Government of Canada Information Requests Submission

For the Nunavut Impact Review Board's (NIRB) Reconsideration of
Agnico Eagle Mines Ltd. "Meliadine Extension" Project Proposal

NIRB File: No. 11MN034

Government of Canada's Information Requests for the Technical Review of Agnico Eagle Mines Limited's Final Environmental Impact Statement Addendum for the "Meliadine Extension" Project Proposal

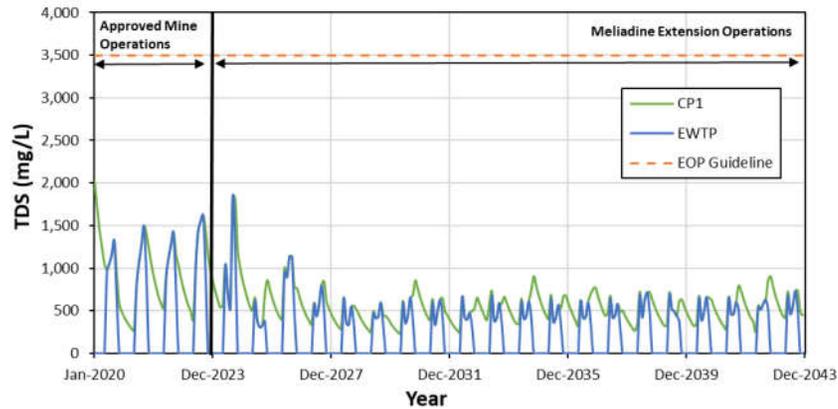
<p>Based on our initial review of the FEIS Addendum for the Meliadine Extension Project, CIRNAC has been unable to identify the rationale for the substantive increases in the volume of discharges to Meliadine Lake relative to the volumes that were predicted at the time the Waterline EA was approved. In addition, we have not identified information to confirm that discharges to Meliadine Lake will be minimized under the Meliadine Extension proposal.</p>	
CIRNAC-IR-07	Total Dissolved Solids (TDS) Concentrations in CP1	<ul style="list-style-type: none"> • Meliadine Extension FEIS Addendum, July 2022 • Appendix H-07 – Meliadine Expansion Water Balance and Water Quality Model -Technical Report • 2021 Meliadine 	<p>Higher than expected Total Dissolved Solids (TDS) concentrations in mine contact water at the Meliadine Mine has triggered several major changes since the project was originally approved. Those changes include: a) the addition of a waterline to discharge mine contact water to Itivia Harbour; and b) an amendment to the Water Licence No. 2AM-MEL1631 to increase the TDS effluent quality criterion (EQC) for discharges to Meliadine Lake from 1,400 mg/L to 3,500 mg/L.</p> <p>Concentrations of TDS in Collection Pond 1 (CP1) are used as an indicator of TDS management challenges experienced at the site. The following figure, which was extracted from AEM’s 2021 Annual Report to the NIRB, indicates</p>	<p>CIRNAC requests that AEM:</p> <ul style="list-style-type: none"> a) Confirm that future TDS concentrations in CP1 are now predicted to remain below 1,000 mg/L; b) Describe the factors that resulted in predicted TDS concentrations in CP1 reducing by more than 70% under the proposed

Annual Report
 (as submitted
 to the NIRB)

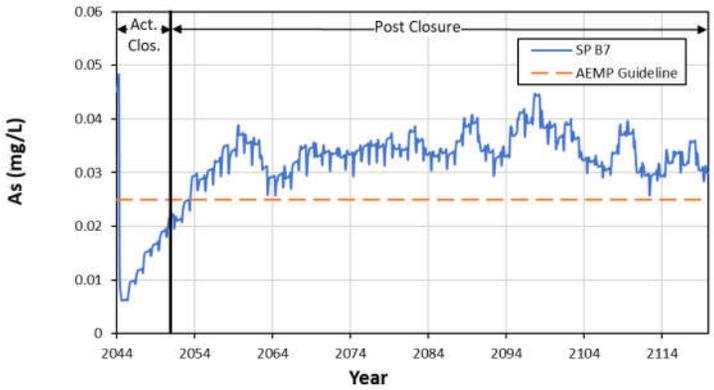
that maximum TDS concentrations in CP1 will consistently approach the
 Emergency Amendment discharge criterion of 3,500 mg/L.

In contrast, the following figure was extracted from Appendix H-07 (Figure 6-4) of the FEIS Addendum. In this case, concentrations of TDS in CP1 are predicted to remain well below 1,000 mg/L after 2026. This represents a reduction of more than 70% when compared to the predictions presented in the 2021 Annual Report.

<p>Based on our initial review of the FEIS Addendum, CIRNAC was unable to determine why TDS concentrations in CP1 are now predicted to be substantively lower than previously anticipated. It is possible that the reduction is attributable to changes in the overall saline water management strategy for the site (e.g., improved segregation of saline drainage from tailings, waste rock and ore, as well as direct discharge from SP B7 to the saline waterline). Nonetheless, further details on the factors that contributed to the major reduction are required.</p>	
<p>CIRNAC-IR-08</p>	<p>Post-Closure Arsenic Concentrations in SP B7</p>	<ul style="list-style-type: none"> • Meliadine Extension FEIS Addendum, July 2022 • Appendix H-07 – Meliadine Extension Water Balance and Water Quality Model -Technical Report 	<p>Saline Pond (SP) B7 will play an important role in saline water management under the Meliadine Mine Extension. CIRNAC was unable to determine the location of SP B7 during our initial review of the FEIS Addendum.</p> <p>The FEIS Addendum (Appendix H-07) indicates that loadings associated with the small volumes of contact water from the tailings storage facility and waste rock storage facility #1 are predicted to maintain elevated concentrations of arsenic in SP B7 during Post-Closure. The elevated arsenic concentrations (as illustrated in in Figure 6-19 which is reproduced below) are consistently above the Aquatic Effects Management Plan (AEMP) guideline of 0.025 mg/L.</p> 	<p>CIRNAC requests that AEM:</p> <ol style="list-style-type: none"> a) Provide a figure illustrating the location of SP B7; b) Indicate whether aquatic species will have access to SP B7 during post-closure; c) Confirm that the predicted arsenic concentrations in SP B7 are spatially averaged and that localized concentrations may be higher; d) Indicate whether sensitivity analyses have been performed to confirm that arsenic concentrations in SP B7 during post-closure will not be
